Product Safety Recall

N202322233 Seat Belt May Not Be Properly Attached

Release Date: January 2021

Revision: 01

5618244

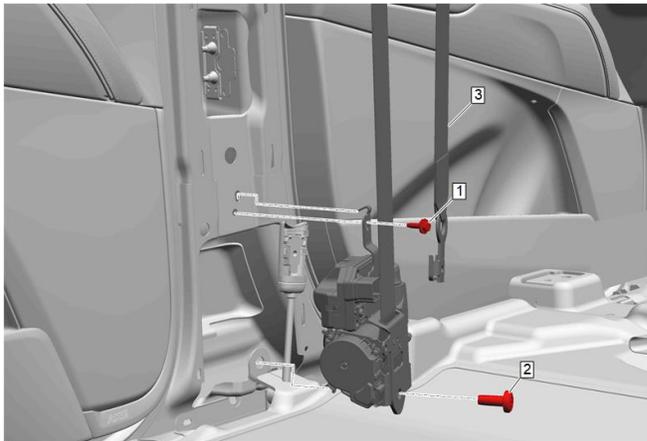
NOTE: The bolt being removed from the vehicle may not have cut the proper threads in the nut when the vehicle was manufactured. If this occurred, expect to feel resistance for the complete bolt length when removing the bolt. When the new bolt is being installed in an unthreaded nut, there will be resistance as the self-threading bolt threads the nut. There will be an initial resistance while the thread is being cut, followed by a reduction in resistance. This is an expected condition. Continue tightening the bolt until the retractor or belt bracket is secured. To complete the installation, tighten the bolt to the proper torque specification.

1. Remove the center pillar lower trim panel. It is not necessary to disconnect the seat belt from the seat belt anchor plate tensioner. Refer to *Center Pillar Lower Trim Panel Replacement* in SI.

2. Remove and discard the lower retractor bolt (2).
3. Install the new retractor mounting bolt. Refer to the note above for installation details. Tighten the new service bolt to 45 N.m (33 lb. ft).
4. Reinstall the center pillar lower trim panel. Refer to *Center Pillar Lower Trim Panel Replacement* in SI.

Second Row Retractor Mounting bolt (2)

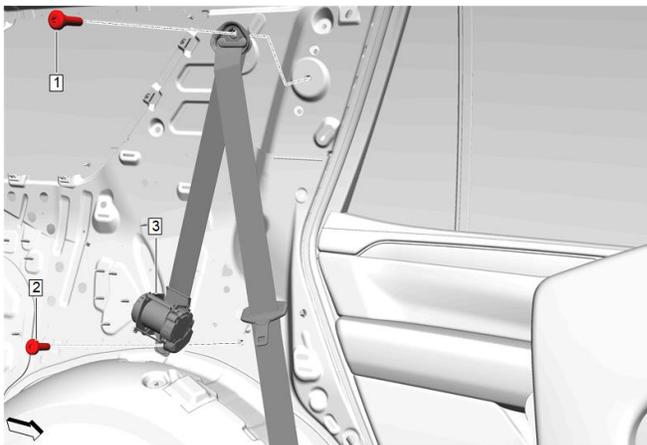
Service Procedure for Second or Third Row Outer Seatbelt Retractor Mounting Bolt

1. Remove the rear compartment floor stowage compartment. Refer to *Rear Compartment Floor Stowage Trim Compartment Replacement* in SI.
2. Remove the quarter lower rear trim panel. Refer to *Quarter Lower Rear Trim Panel Replacement* in SI.

3. Remove the second or third row seat belt retractor bolt as required. Discard the bolt.
4. Install the new retractor mounting bolt. Refer to the note above for installation details. Tighten the new service bolt to 45 N.m (33 lb. ft).
5. Reinstall the quarter lower rear trim panel. Refer to *Quarter Lower Rear Trim Panel Replacement* in SI.
6. Reinstall the rear compartment floor stowage compartment. Refer to *Rear Compartment Floor Stowage Trim Compartment Replacement* in SI.
